Development Review Comments

2026-103-PAM

WESTAT REDEVELOPMENT

PRE-APPLICATION MEETING SITE PLAN

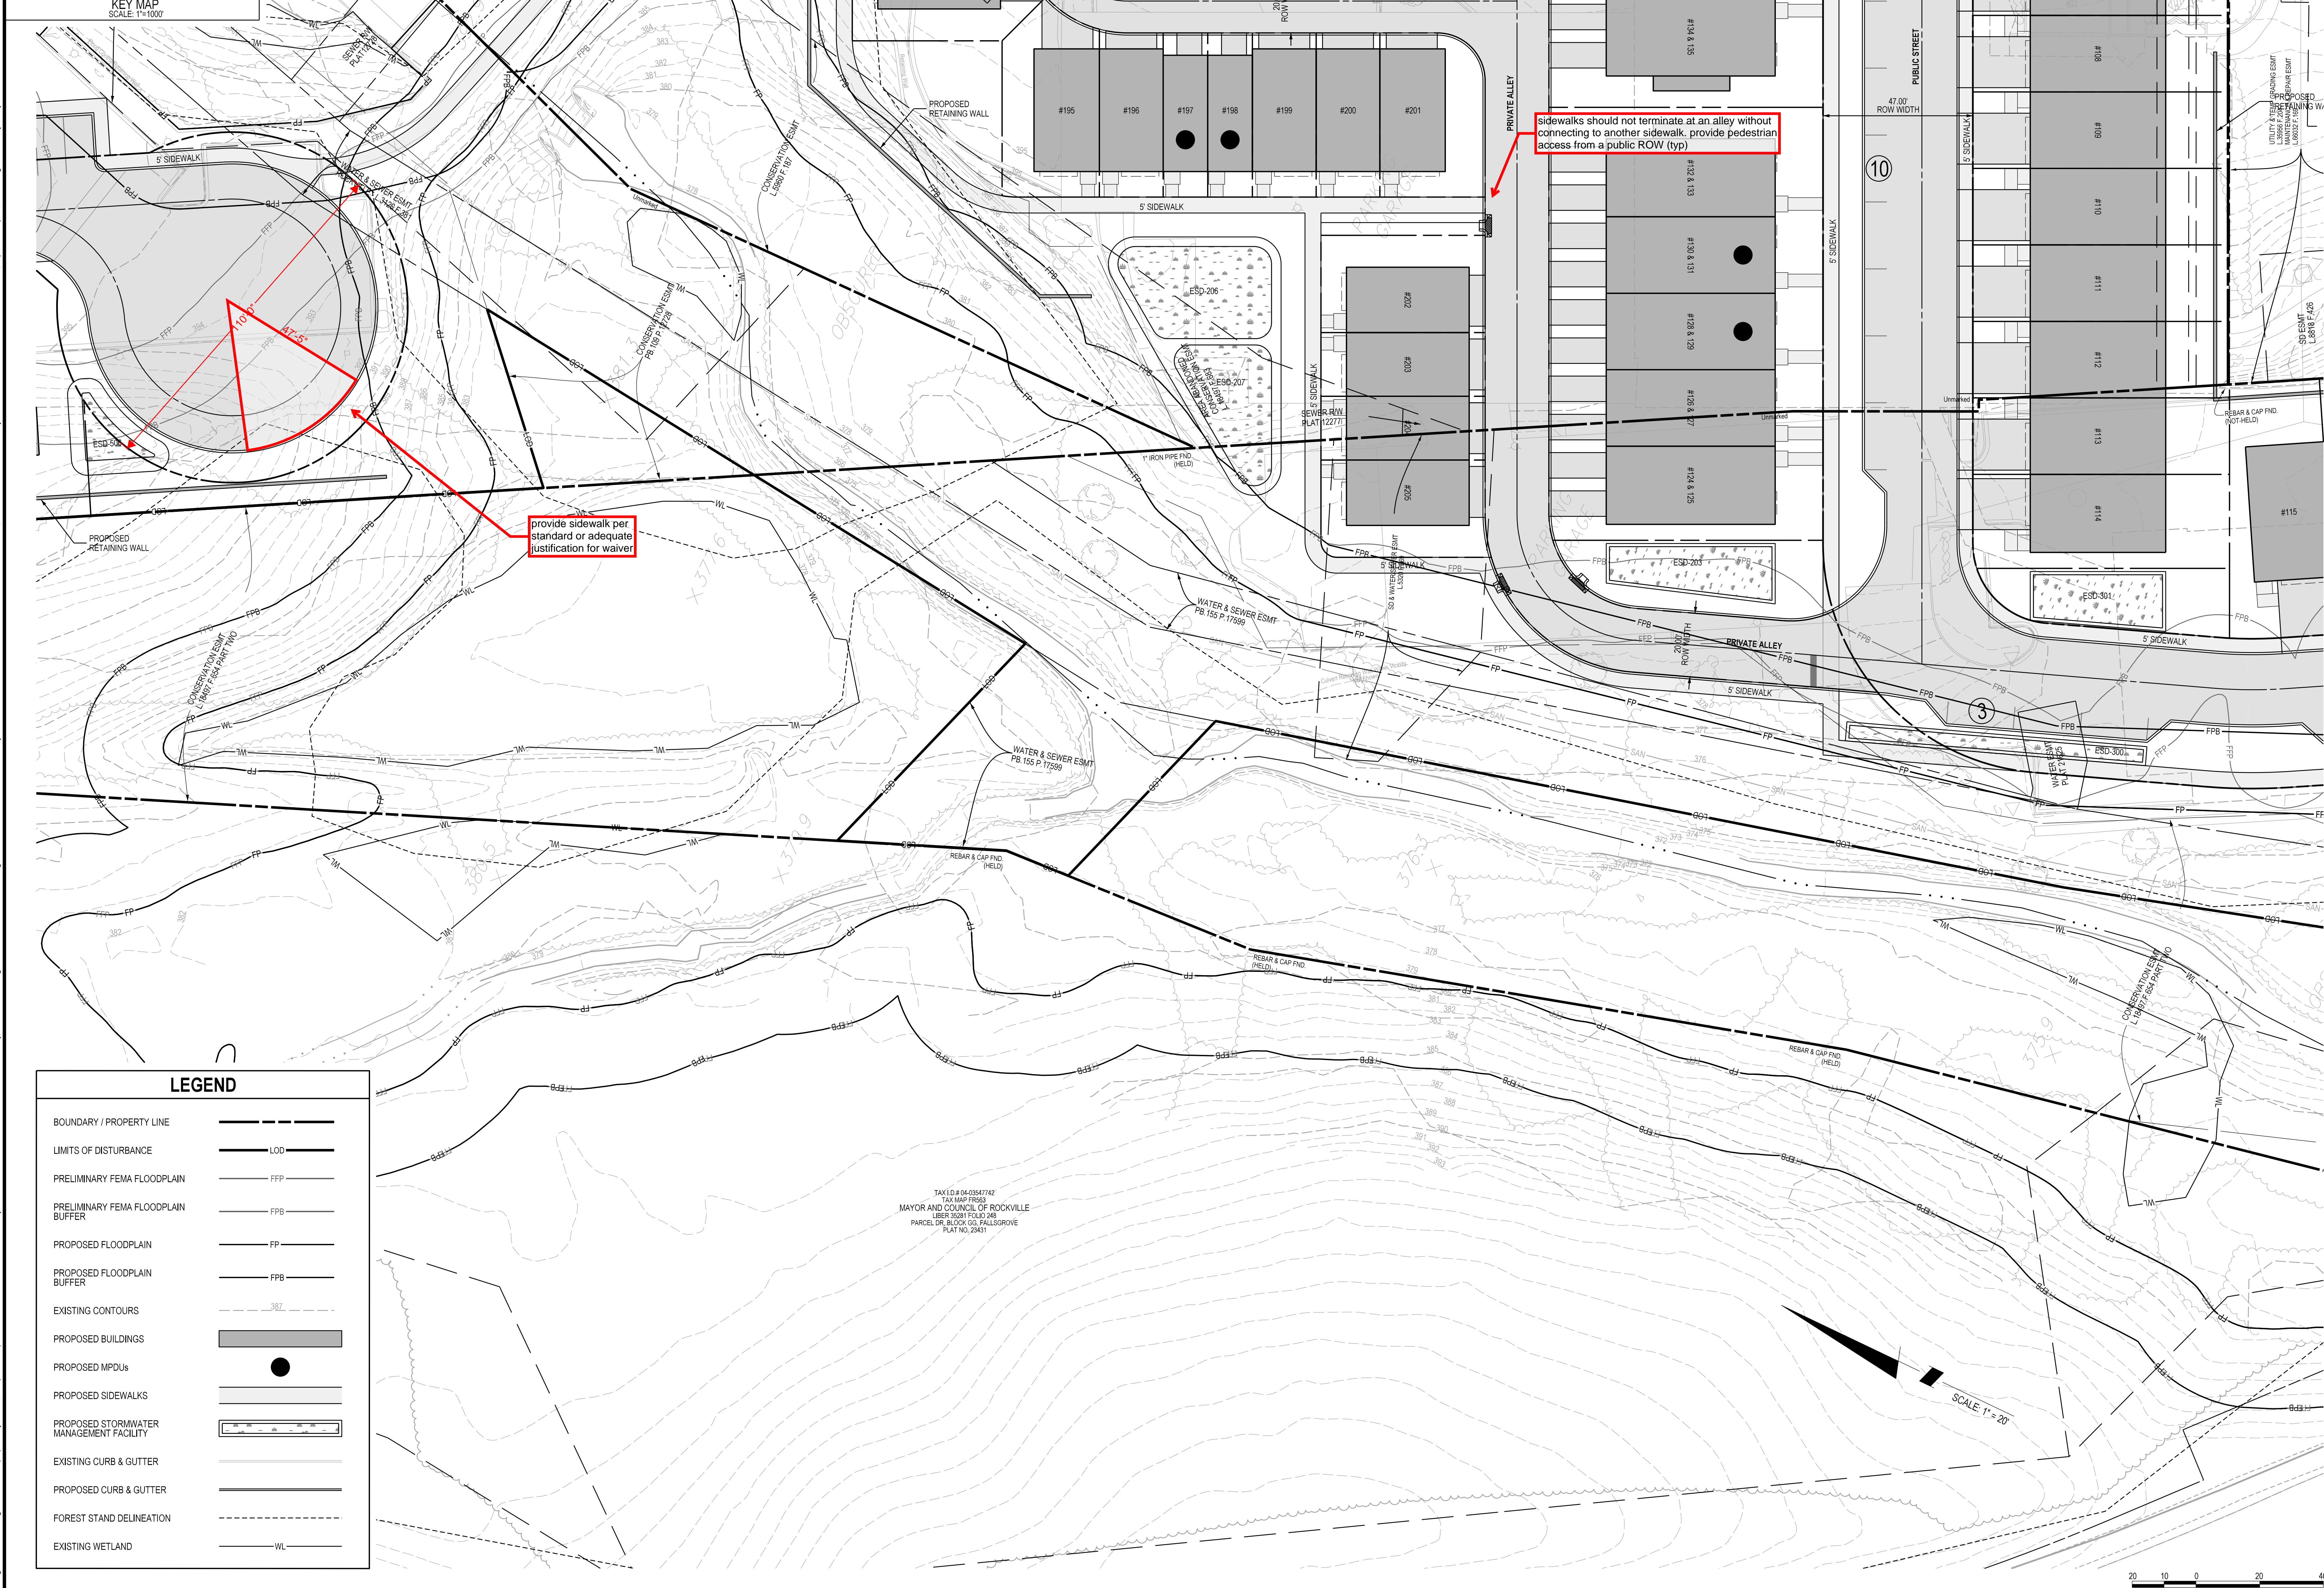
verify physical condition of stump, replace monument through record plat process as necessary

Per City code Sec. 21-47, all roads within the City must connect to another road or provide a cul-de-sac to allow for turn-around area.

Min. Supported ROW width is 55'

remove parking

label existing easements (typ)

update waterways, stream valley buffer, wetlands, City floodplains outfalling from Falls Grove Pond 3 on west side of Rt. 28 per NRI/FSD
